# Submissions Report

SSD-74670720

38-42 Anderson, 3 McIntosh and 2 Day  
Streets, Chatswood

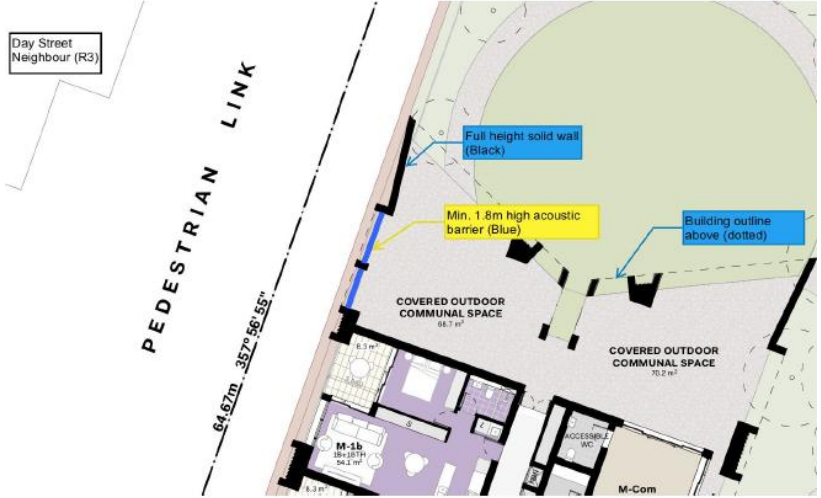
ITEM REFERENCE	SUMMARY OF ISSUE RAISED	RESPONSE
<b>1. Car parking</b>		
DPHI-1	<p>The proposal includes 360 car parking spaces allocated to market rate residential apartments, which is 96 spaces more than the non-discretionary development standard under section 19 of the Housing SEPP. The Chatswood CBD is a highly accessible location, serviced by various modes of high-frequency public transport.</p> <p>The Department therefore requests that the number of residential car parking spaces be reduced to align with the minimum Housing SEPP car parking rates. Additionally, the number of non-residential car parking spaces should not exceed the maximum rates specified in the Willoughby DCP.</p>	<p>The minimum car parking requirement is prescribed as a non-discretionary development standard under Section 19(2)(e) and (f) of the Housing SEPP, which if complied with, prevents the consent authority from requiring more onerous standards.</p> <p>Specifically, Section 4.15(2) of the EP&amp;A Act states that if a DA complies with the non-discretionary development standards in an EPI, the consent authority:</p> <ul style="list-style-type: none"> <li>(a) <i>is not entitled to take those standards into further consideration in determining the development application, and</i></li> <li>(b) <i>must not refuse the application on the ground that the development does not comply with those standards, and</i></li> <li>(c) <i>must not impose a condition of consent that has the same, or substantially the same, effect as those standards but is more onerous than those standards, and the discretion of the consent authority under this section and section 4.16 is limited accordingly.</i></li> </ul> <p>Given the parking standard provides a minimum rate, the proposed car parking provision beyond the minimum rates still meets the controls in Section 19(e) and (f) of the Housing SEPP. The proponent has used the DCP as a guideline and has sought deliver parking as close as possible to what the DCP recommends.</p>

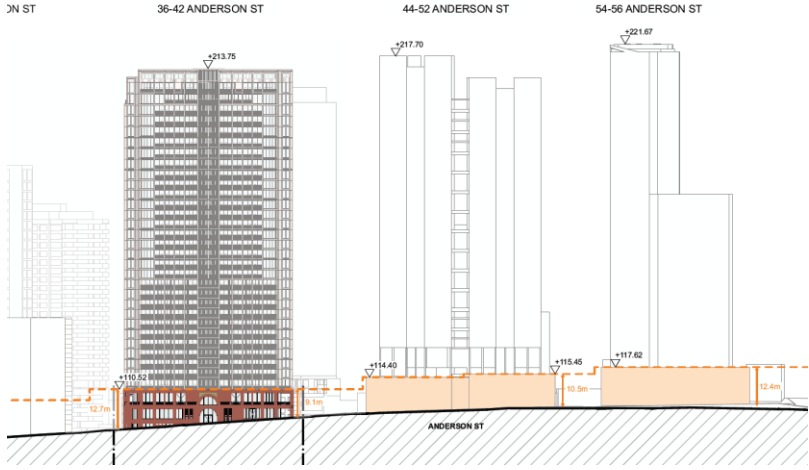
ITEM REFERENCE	SUMMARY OF ISSUE RAISED	RESPONSE
		<ul style="list-style-type: none"> <li>• <b>Visual Impact:</b> Whilst visible from private views, the skilful design incorporates measures to reduce view impact on nearby residential properties and view sharing is achieved. View loss associated with the proposal ranges from just moderate, to negligible and that the proposed development is largely compatible with its context and will not impact on the current views of the Chatswood CBD skyline from public spaces such as Beauchamp Park. Further, view sharing is achieved as iconic views and vistas such as Coogee, Manly Beach, North head and Sydney Harbour are maintained.</li> </ul>
<p><b>2. Affordable housing contribution</b></p>		
<p>WCC-2</p>	<p>While Council acknowledges the decision of the Planning Panel regarding the affordable housing contribution applicable to the site (in relation to PP-2022-4316), Council continues to strongly support application of a 10% affordable housing contribution across all relevant sites, including this site, in accordance with WLEP 2012. The subject site is experiencing significant uplift and is capable to provide a 10% affordable housing contribution in line with other MU1 Mixed Use zoned land in the Chatswood CBD.</p> <p>Further, the infill affordable housing bonuses were not intended to replace existing affordable housing requirements and this was clearly communicated throughout the exhibition and finalisation of the SEPP.</p> <p>The SSDA should satisfactorily address s 7.32 (3) (a) of the Environmental Planning and Assessment Act 1979 and s 15 of the SEPP (Housing) 2021, and s 7.32 (1) and (3) (c) of the Environmental Planning and Assessment Act 1979, in regards the affordable housing proposed (both in regards WLEP 2012</p>	<p>The Planning Proposal (PP-2022-4316) was recommended for finalisation as of 24 June 2025 and on 4 July 2025 SNPP determined to recommend to the Minister that the plan be made. The Planning proposal provides for 7% LEP affordable housing across the site, excluding 38 Anderson (which will remain as 10% affordable housing).</p> <p>We are awaiting legal instrument to be drafted by Parliamentary Counsel before then being gazetted. We anticipate this will occur before 29 August 2025 when the Gateway Determination expires.</p> <p>Monetary contributions are proposed to align with this requirement.</p> <p>The GFA calculation has been pro-rated as below:</p> <p>Total site area: 4,445sq.m (100%)</p> <p>Site area for 38 Anderson Street: 1318.1sq.m (<b>29.65%</b>)</p> <p>Total residential GFA: 30,124.4</p> <ul style="list-style-type: none"> <li>• Excluding 38 Anderson Street: 70.35% of residential GFA (21,192.52) at 7% AH contribution = <b>1483.48sq.m</b></li> <li>• 38 Anderson Street: 29.65% of residential GFA (8931.88) at 10% AH contribution = <b>893.19sq.m</b></li> </ul>

ITEM REFERENCE	SUMMARY OF ISSUE RAISED	RESPONSE
	<p>and the SEPP). This information should be submitted as part of this SSDA.</p> <p>Having regard to any final decision on this matter, affordable housing conditions are provided at Attachment 3.</p>	<p><b>Total LEP affordable housing contribution = 2,376.67sq.m</b></p>
<p><b>3. Infrastructure contributions</b></p>		
<p>WCC-3</p>	<p>Council welcomes the opportunity to confirm the requirements under Willoughby Local Contributions Plan 2019 prior to the finalisation of any relevant conditions, should the application proceed to the drafting of a consent. In calculating infrastructure contribution payments, the proponent must consider the applicable rates and any credits available for the existing development on the site.</p> <p>Exemptions for affordable housing apply only to dwellings dedicated in perpetuity in accordance with the WLEP and there is no exemption for housing managed as affordable housing temporarily. Infrastructure contribution conditions are provided in Attachment 3.</p>	<p>Section 2.6 of Willoughby's 7.11 Contribution Plan stipulates certain types of development that are 'exempt' from paying contributions under the plan, which specifically calls out affordable housing as exempt from paying contributions.</p> <p>Given that the contributions plan does not give a definition of 'social housing and affordable housing', it is considered that affordable housing provided as a monetary contribution is still deemed to satisfy this criterion for exemption.</p> <p>Therefore, it is our view that it is appropriate for an exemption to be granted for the 'affordable housing' dwellings, with the remainder of the development and market housing to be levied as usual under the 7.11 Contribution Plan.</p>

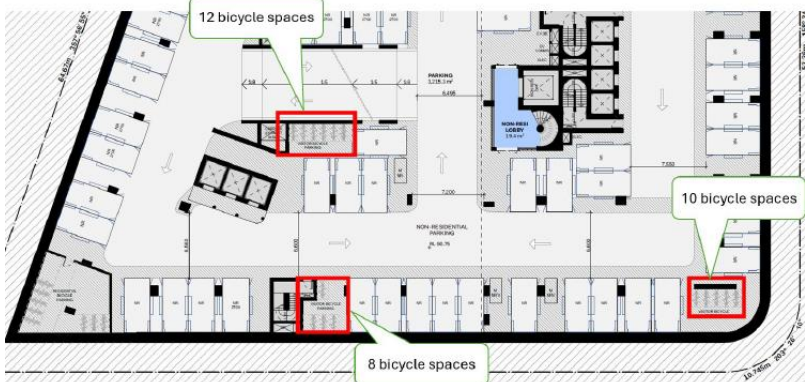
<b>5. Excessive car parking spaces</b>		
WCC-5	<p>Council seeks an approach to car parking in the Chatswood CBD that aligns with the significant and successful investment in the Metro, rather than default provisions that apply more broadly across NSW or outside metropolitan transport precincts. In considering this SSDA, Council requests that emphasis be placed on the planning document that prescribes the lowest applicable car parking rate within the Chatswood CBD railway precinct—namely, the Willoughby Development Control Plan (WDCP), Part F: Transport and Parking Management. Strategic planning and traffic modelling for the Chatswood CBD are based on the enforcement of low parking rates to encourage a shift away from car use and to support the substantial public investment in the Chatswood Metro and other transport infrastructure.</p> <p>The proposed number of residential car spaces is 386. This significantly exceeds the maximum residential car space rate of 127 in Council's WDCP. The SSDA is requested to be amended</p>	<p>The minimum car parking requirement is prescribed as a non-discretionary standard under Section 19(2)(e) and (f) of the Housing SEPP, which if complied with, prevents the consent authority from requiring more onerous standards.</p> <p>Specifically, Section 4.15(2) of the EP&amp;A Act states that is a DA complies with the non-discretionary development standards in an EPI, the consent authority:</p> <p><i>(a) is not entitled to take those standards into further consideration in determining the development application, and</i></p> <p><i>(b) must not refuse the application on the ground that the development does not comply with those standards, and</i></p> <p><i>(c) must not impose a condition of consent that has the same, or substantially the same, effect as those standards but is more onerous than those standards, and the discretion of the consent authority under this section and section 4.16 is limited accordingly.</i></p>

ITEM REFERENCE	SUMMARY OF ISSUE RAISED	RESPONSE
	<p>to have car parking consistent with the location's exceptional access to transit and WDCP car parking rates.</p>	<p>Given the parking standard provides a minimum rate, the proposed car parking provision beyond the minimum rates still meets the controls in Section 19(e) and (f) of the Housing SEPP.</p> <p>The Proponent acknowledges Council's intent to encourage the use of public transport and reduce reliance of private vehicles. In this regard, it is expected that residents will be walking to access the local shops and services given the site's adjacent proximity to the CBD and the Rail Station and Metro.</p> <p>Further, adequate car parking provision is required to cater to the travel needs of downsizers, aging owner-occupiers and young families as public transport does not meet all the travel needs of these residents, especially for destinations not well-served by public transport. It is also expected that the use of cars for recreational purposes will occur outside of peak periods and hence is unlikely to result in significant traffic generation.</p>
